LINCOLN PARK PLANNING COMMISSION

881 Southfield – Auto Sales

Site Plan Review

Applicant	Roger Canzano
Project	Auto Sales
Address	881 Southfield Rd. Lincoln Park, MI 48146
Date	June 24, 2020
Request	Conceptual Site Plan Review
Recommendation	None - Advisory Only

SHEET TITLE
PROJECT NAME
 ADD USED CAR SALES TO
 EXISTING AUTO REPAIR
SITE PLAN

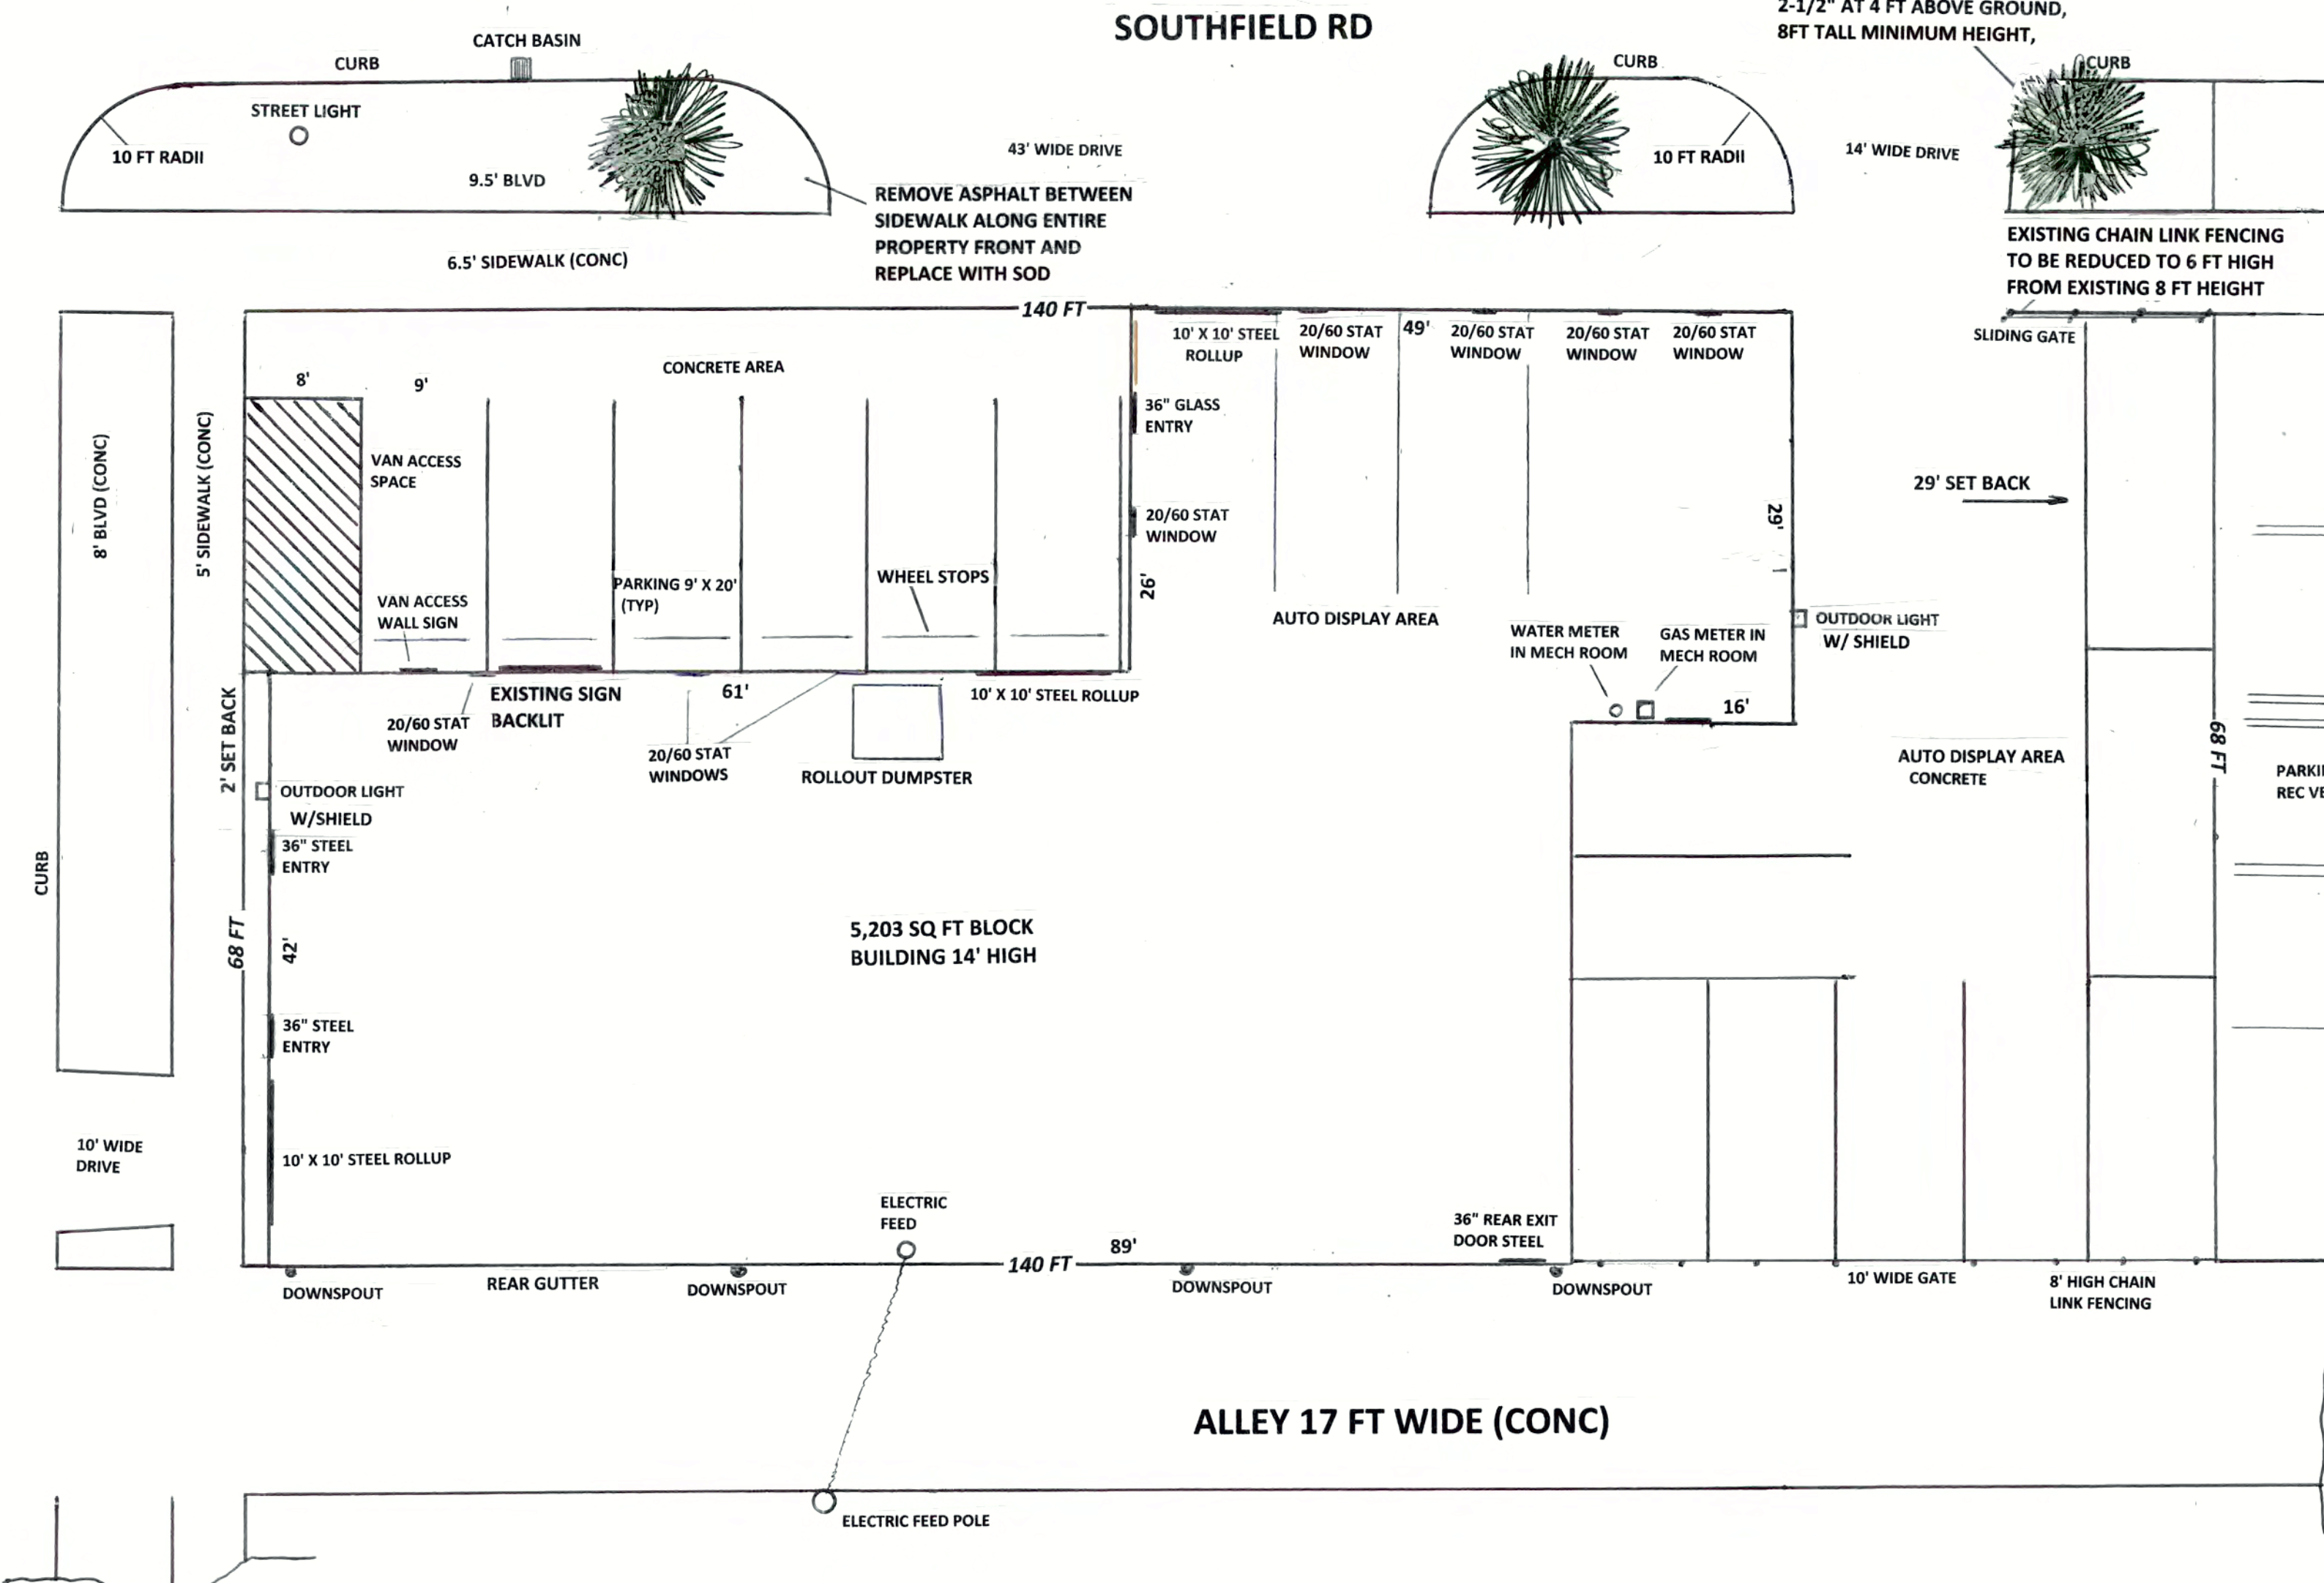
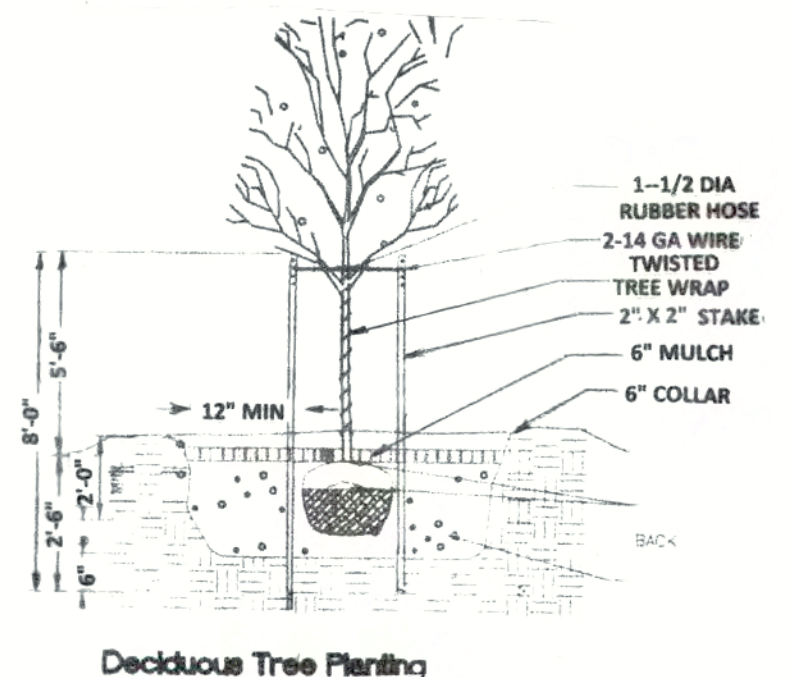
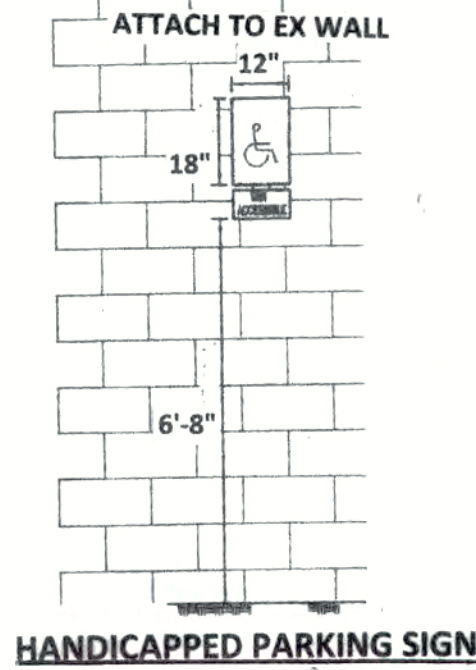
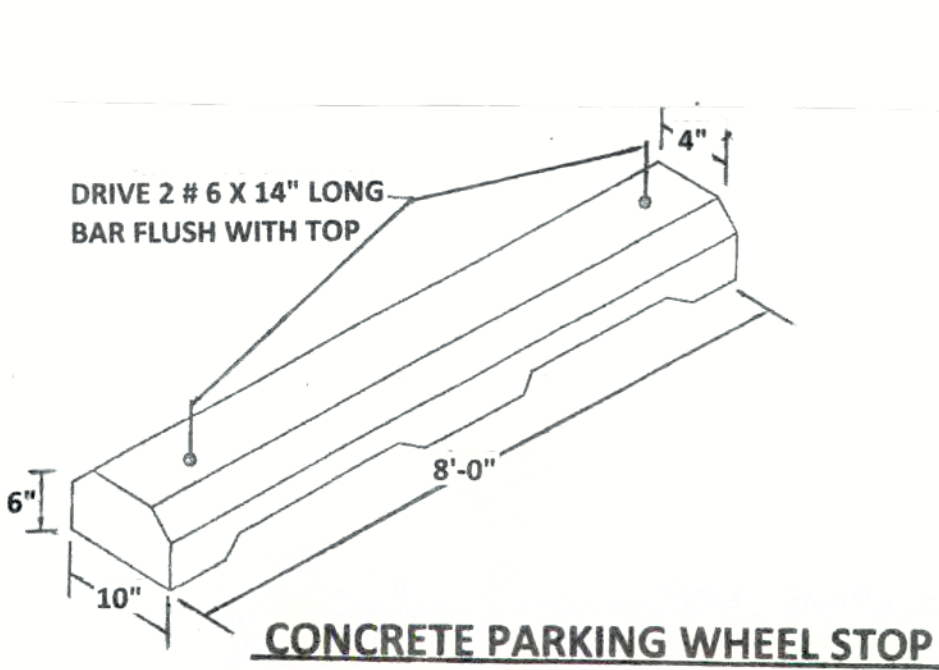
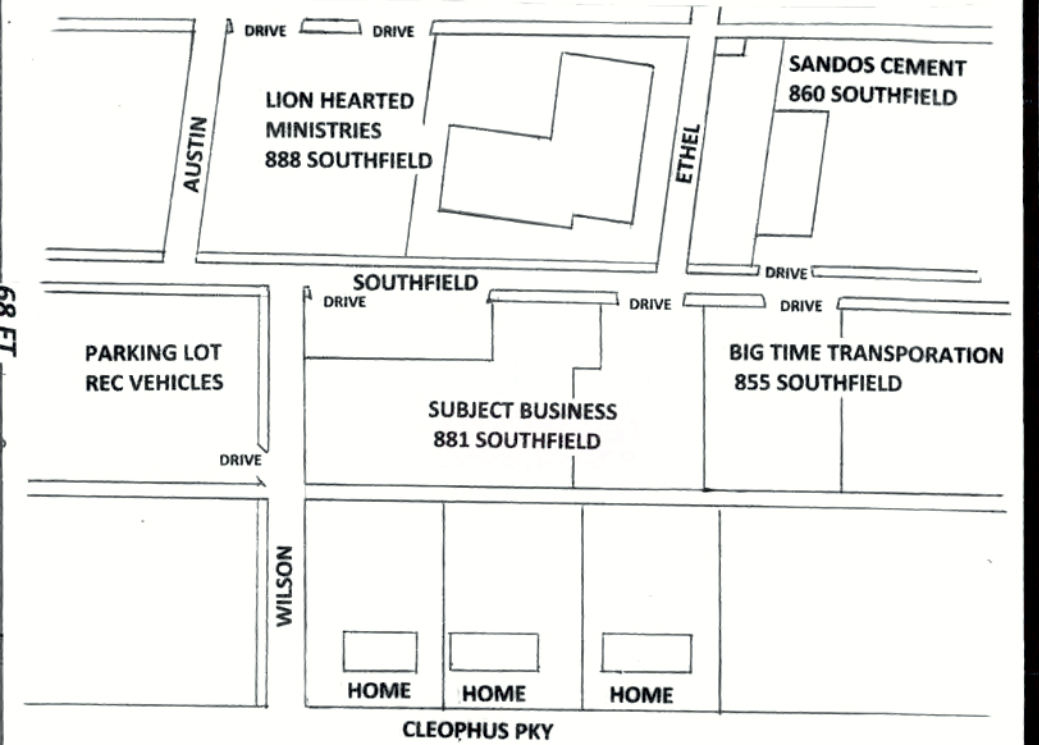
- Applicant shall indicate clear lines of sidewalks and curb lines on the Site Plan, Sheet 01.

Parking may be an insurmountable issue for this site. The site plan proposes a total of 6 spaces for the site, which is generally in the same area as a black-topped, unstriped area that is currently serving as the parking lot. Both uses combined require 13 spaces, and the Planning Commission has the power to waive this requirement based on evidence of lower demand. However, the current auto repair use has inappropriately paved over the lawn areas adjacent to both Southfield Road and Wilson Avenue, and this space is regularly observed in use for vehicle storage, suggesting that the current parking facilities are not

meeting the need of the existing use – much less capable of accommodating a second use. The site plan shows the restoration of the lawn areas and sidewalk along Southfield Road, but in that configuration, there is no maneuvering aisle and so vehicles would have to drive on the sidewalk in order to access the parking spaces. Such vehicles would also have to use the sidewalk for backing out of spaces. This arrangement cannot be approved.

- The driveways as proposed do not meet the standards for width, radius, or number. These standards shall be considered in the revised parking lot proposal.*

Required	Proposed	Compliance
Street Landscaping	Greenbelt, 10' width minimum with groundcover	Proposed 9.5 Blvd. to remove asphalt between sidewalk along entire property front and replace with sod; same is required on Wilson Ave	NOT MET
	1 tree and 4 shrubs per 40' of street frontage <i>Southfield Rd:</i> <i>140 total = 4 trees and 14 shrubs</i> <i>Wilson Ave: 68 ft = 2 trees and 8 shrubs</i>	Provided 3 deciduous tree plantings (Oak), Minimum diameter 2 ½ inch ft above ground, 8ft tall minimum height. Street trees not shown on Wilson Ave.	NOT MET
	Where headlights from parked vehicles will shine into the ROW, may require a totally obscuring hedge	The parking area that abuts Southfield Road must be redesigned before this item can be evaluated	N/A
Interior Landscaping	10% of total lot area landscaped, including groundcover <i>(9,520 sf *0.1) = 952 sf landscaping</i>	Not provided; the entire open space is used for the parking space area and the auto display area.	NOT MET

The site is served by an existing light pole located on the corner of Southfield Rd and Wilson Ave. The Site Plan, sheet 01 and Elevations, sheet 06 indicate two outdoor light fixtures with shields, one on the left side elevation facing the auto display area and one on the left side elevation facing the Wilson Ave.

- Applicant shall work with the Planning Commission to direct desired number of parking spaces.
- Proposed design may not require backing or maneuvering on the public sidewalk.
- Applicant shall provide a wall or curb at least 6 inches high, or steel posts between the sidewalks on Southfield Rd and Wilson Ave and the Parking space in accordance with §1290.05 of the Code of Ordinance.
- Applicant shall replace the 8 ft high chain link fence at rear of display area with 6 ft solid masonry wall, ornamental on both sides, with bumper guards for the outdoor auto display parking space.

- Applicant shall indicate clear lines of sidewalks and curb lines on the Site Plan, Sheet 01.
- Applicant shall work with the Planning Commission to direct desired number of parking spaces.

- Proposed design may not require backing or maneuvering on the public sidewalk.
- Applicant shall provide a wall or curb at least 6 inches high, or steel posts between the sidewalks on Southfield Rd and Wilson Ave and the Parking space in accordance with §1290.05 of the Code of Ordinance.

- Applicant shall replace the 8 ft high chain link fence at rear of display area with 6 ft solid masonry wall, ornamental on both sides, with bumper guards for the outdoor auto display parking space.

ELEVATIONS

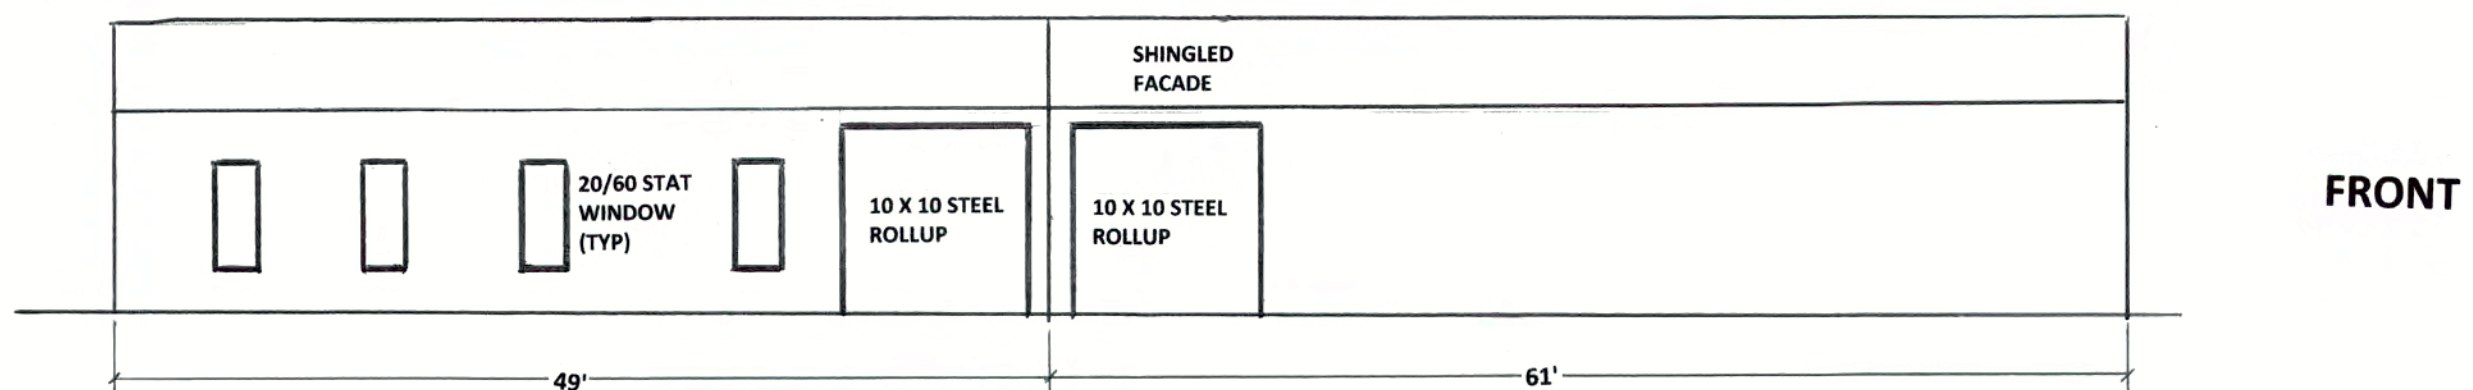
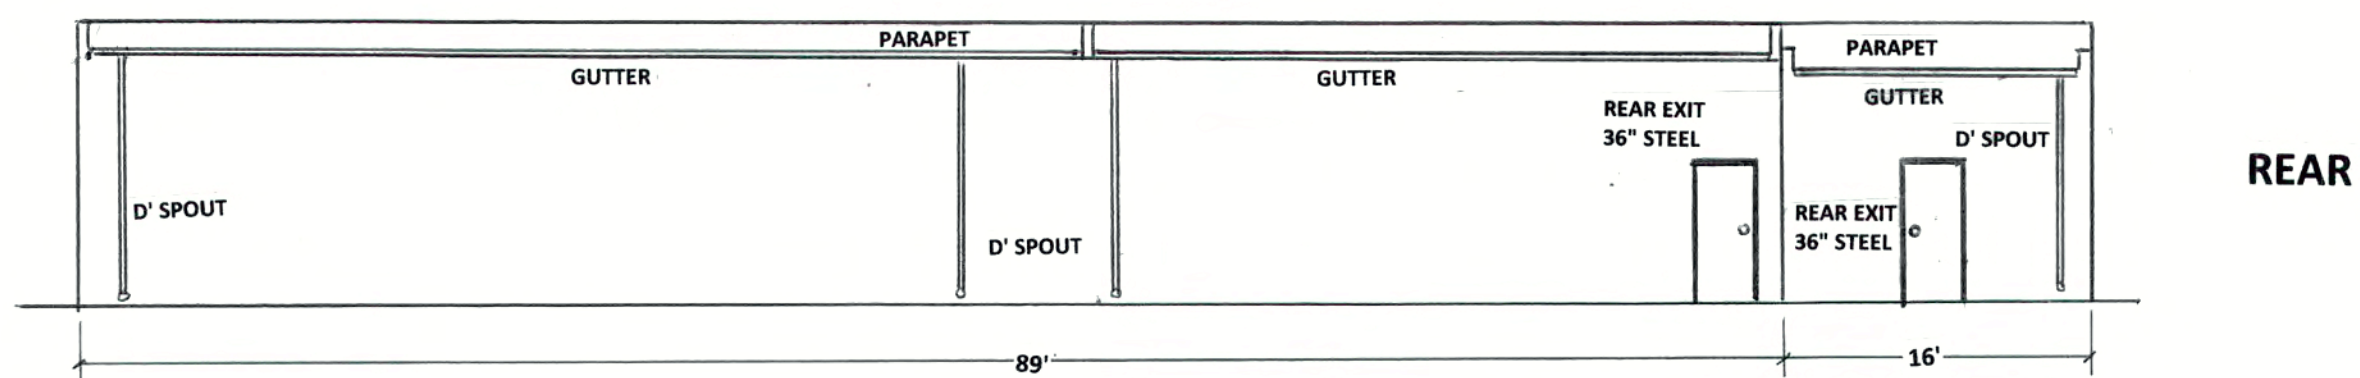
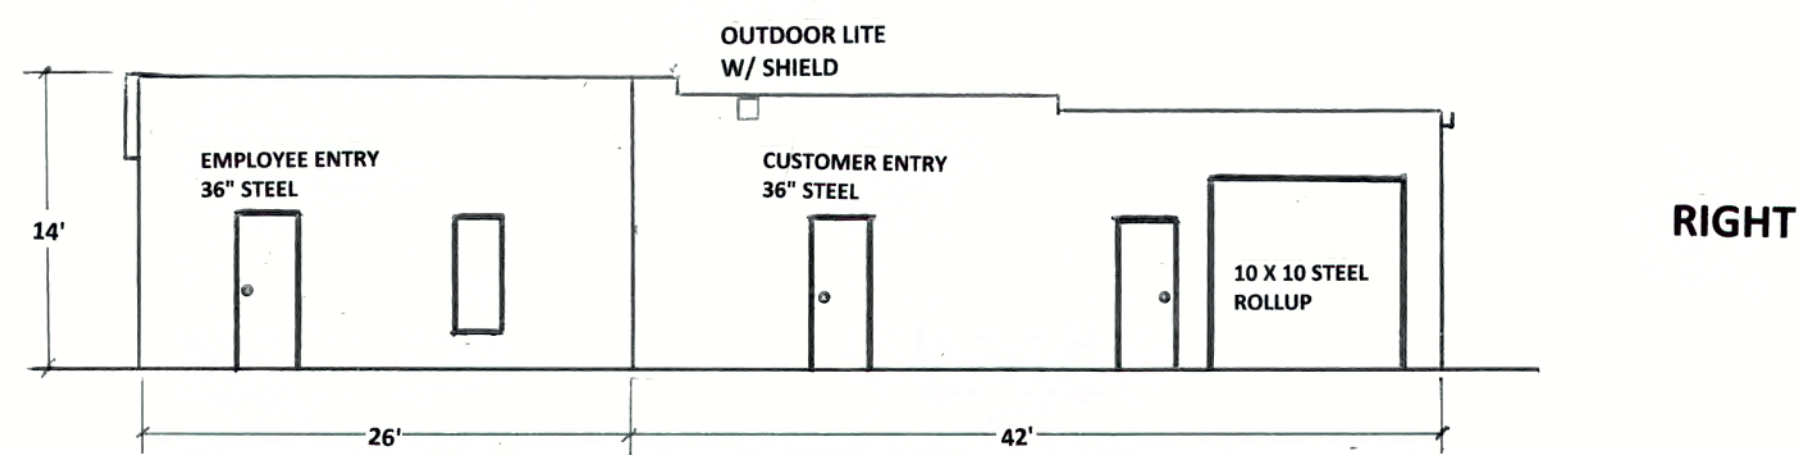
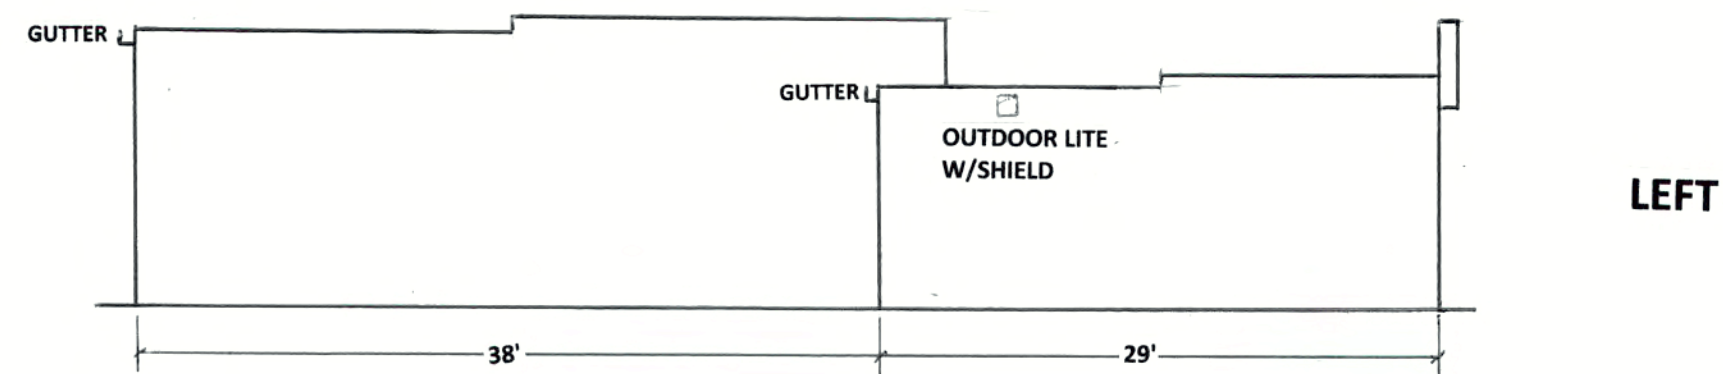
The building materials and transparency (windows) do not meet the standards, but may be preserved so long as the nonconformity is not increased. Several windows are on the existing building but not shown on the plans. These cannot be removed, as the existing property does not meet the transparency requirement. The elevation drawings shall show all features, and shall specify each façade material.

- Applicant shall indicate a clear written description of the unidentified building materials for all the elevations on sheet 06, Elevations.
- Applicant shall clearly indicate any variations between the existing elevations and the new proposed elevations. Elevations - Sheet 06, Site Plan - Sheet 01 should reflect the same number of windows and/or openings. Ex Floor Plan -Sheet 03 should also reflect the same number of windows and opening of the existing building.

- Applicant shall indicate a clear written description of the unidentified building materials for all the elevations on sheet 06, Elevations.
- Applicant shall clearly indicate any variations between the existing elevations and the new proposed elevations. Elevations - Sheet 06, Site Plan - Sheet 01 should reflect the same number of windows and/or openings. Ex Floor Plan - Sheet 03 should also reflect the same number of windows and opening of the existing building.
